UPPER UWCHLAN TOWNSHIP
BOARD OF SUPERVISORS
WORKSHOP

Reference: Parcel 5C (Byers Station) – Lot 2B
Amended Final PRD Plans – Second Review
Upper Uwchlan Township, Chester County, PA

Byers Station Parcel 5C Lot 2B – Revised Amended Final PRD Plan

PR2.1: PROPOSED BUILDING ELEVATIONS

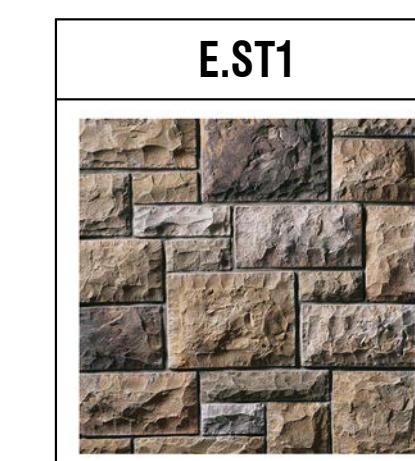
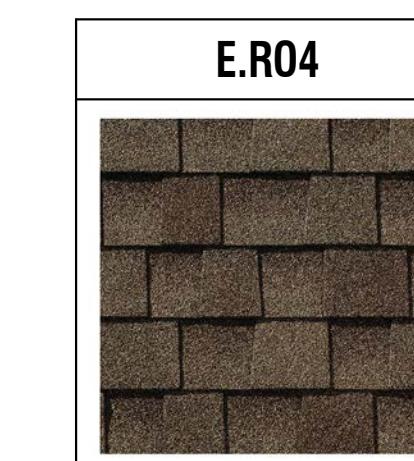
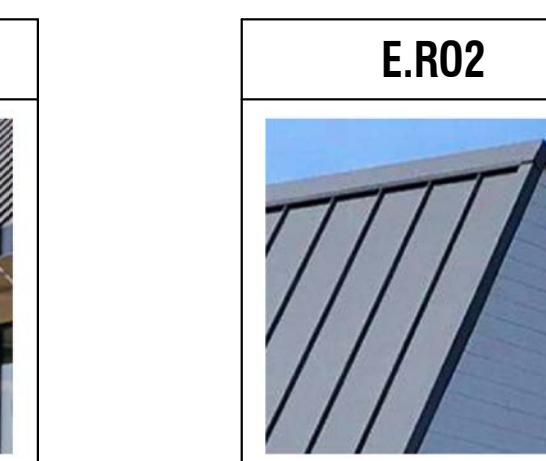
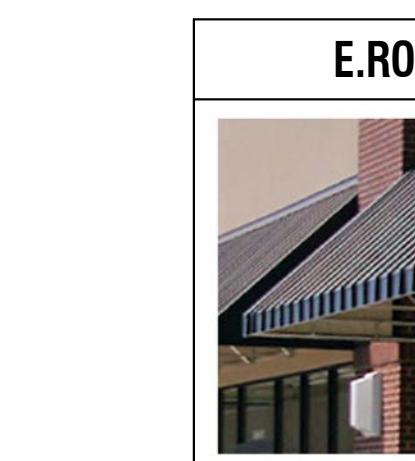
1. *Paragraph B.3.(f). requires a break in the façade after a maximum length of 150'; the proposed day care center does not appear to comply with this requirement.*

The specific condition states “*Building mass shall be broken through façade offsets of at least 10 feet or roofline changes, with maximum single façade length of 150’;*” The applicant is attempting to address this condition through the use of awnings rather than true offsets in the foundation. **The Planning Commission should review and determine if this meets the spirit of this condition.**

3. We are in support of applicant using roofline changes to break the proposed building mass as per Resolution #07-06-99-09 for a tentative approval for Byers Village subdivision (Section II.B.3.f); however, the applicant shall address the comment above as it relates to the usage of flat roofs.

- the school building is the only building longer than 150' and the elevations show roof line changes, in compliance with regulations;
- the back sides of the buildings, along Pottstown Pike, will look like the front;
